Refer to: HSA-1/CC72

In his November 21 letter to Mr. Richard Powers of my staff, your consultant, Mr. James Albritton, requested the Federal Highway Administration's (FHWA) acceptance of a modified Slotted Rail Terminal (SRT) as an National Cooperative Highway Research Program (NCHRP) Report 350 test level 3 (TL-3) terminal for w-beam guardrail. To support this request, he also sent the Texas Transportation Institute (TTI) final report entitled "Testing and Evaluation of the Linear SRT with Steel HBA Posts," dated November 2000, and copies of the test video tapes.

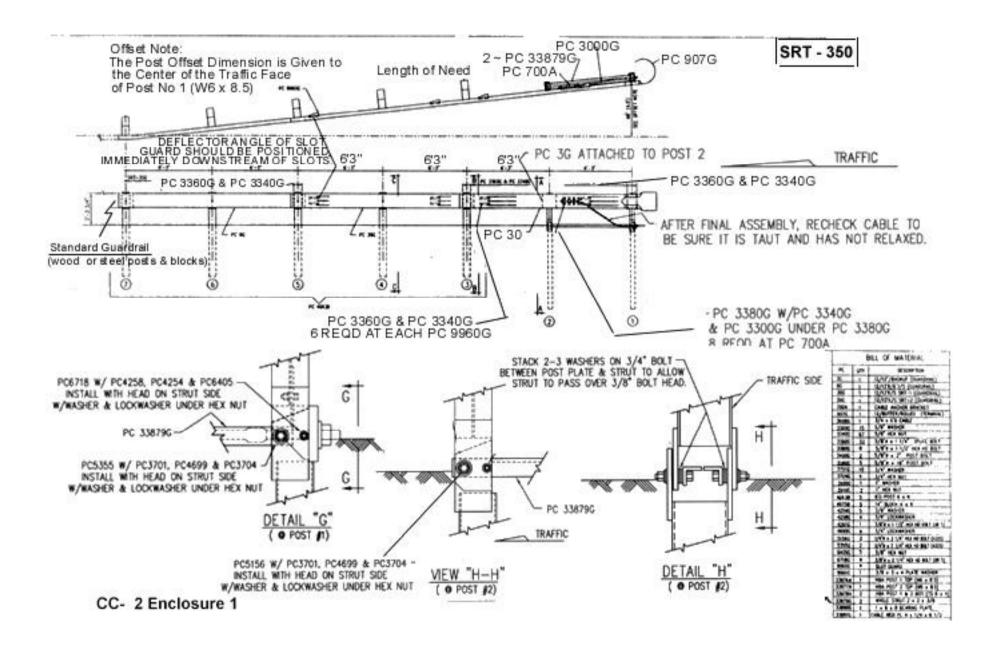
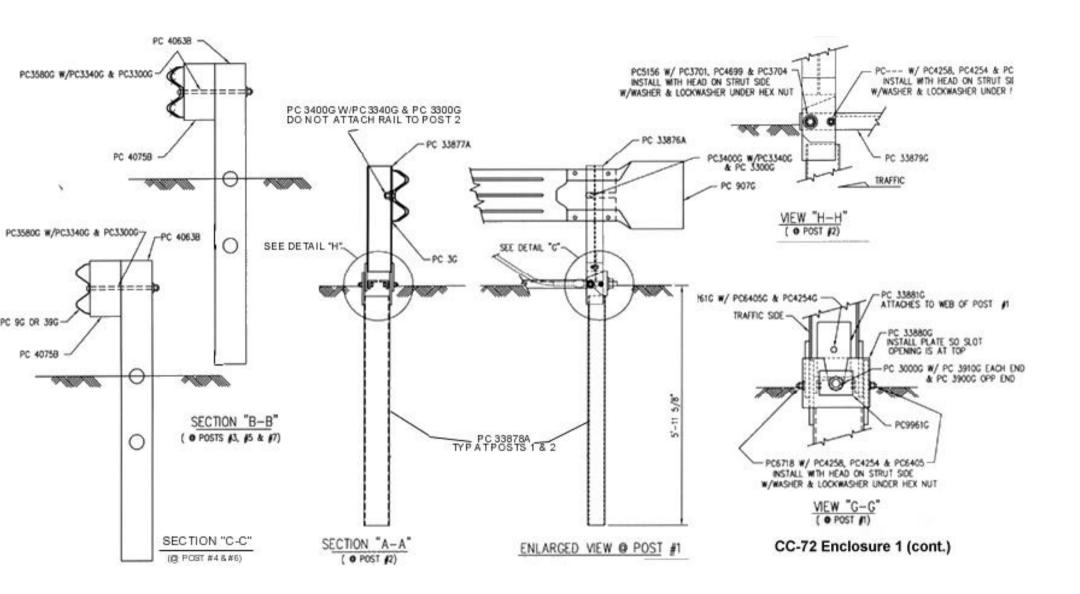
The tested design consisted of an 11.4-m (37.5-foot) straight flare with the first post offset 1.2 m (4 feet) from the downstream guardrail. The two anchor posts were steel Hinged Breakaway (HBA) posts while the remaining posts were standard 1830-mm (6-foot) long CRT posts. The HBA posts were modified slightly from the design accepted for use with the ET-2000 terminal. These modifications included the use of  $102 \times 152 \times 5$  mm (4 x 6 x 3/16 in) soil tubes in lieu of W150 x 13 (W6 x 8.5) steel stub posts, and two parallel ground struts between post no. 1 and post no. 2. To prevent premature failure of the end post in a downstream hit, the rail to post attachment hole at post no. 1 was slotted to the end of the beam element. Enclosure 1 shows these and other design details.

The design that you actually tested used four CRT posts. In reviewing the tests, all of which met Report 350 evaluation criteria, it was noted that the use of a standard line post at post no. 7 contributed to a relatively high roll angle in test 3-31 and to a higher than expected pitch angle in test 3-35. These results can be directly related to the vehicle striking post no 7 in both tests. After discussions between Mr. Richard Powers of my staff and Mr. Albritten, you agreed to specify a fifth CRT post at post position no. 7. This change from the tested design is reflected in drawing no. SS 351 dated December 12, 2000 (Enclosure 1). The summary results of the three tests you conducted are enclosed (Enclosure

Considering the above, the modified linear SRT terminal with an offset of 1.2 m (4 feet), two steel HBA posts, and five CRT posts may be considered acceptable for use on the National Highway System as a TL-3 w-beam terminal when such use is requested by a State or local transportation agency. As with all gating, non-energy absorbing terminals, it should not be used in locations where there is inadequate run out distance immediately behind and parallel to the railing itself. Based on the final position of the pickup truck in test 3-31, approximately 53 m (175 feet) of barrier proper should be used in advance of a fixed object hazard when a non-energy absorbing design like the SRT is used to terminate the barrier.

Figure 23. Summary of results for test 400001-SRT2, NCHRP Report 350 test 3-35.

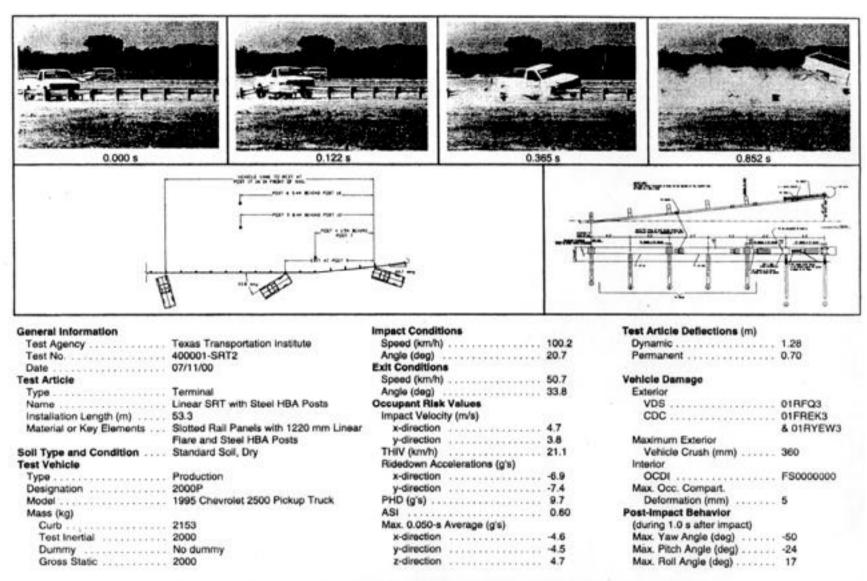
2). Based on the results of test 3-35, the beginning length-of-need of the linear SRT is at post no. 3, approximately 3.8 m (12.5 feet) from the end.
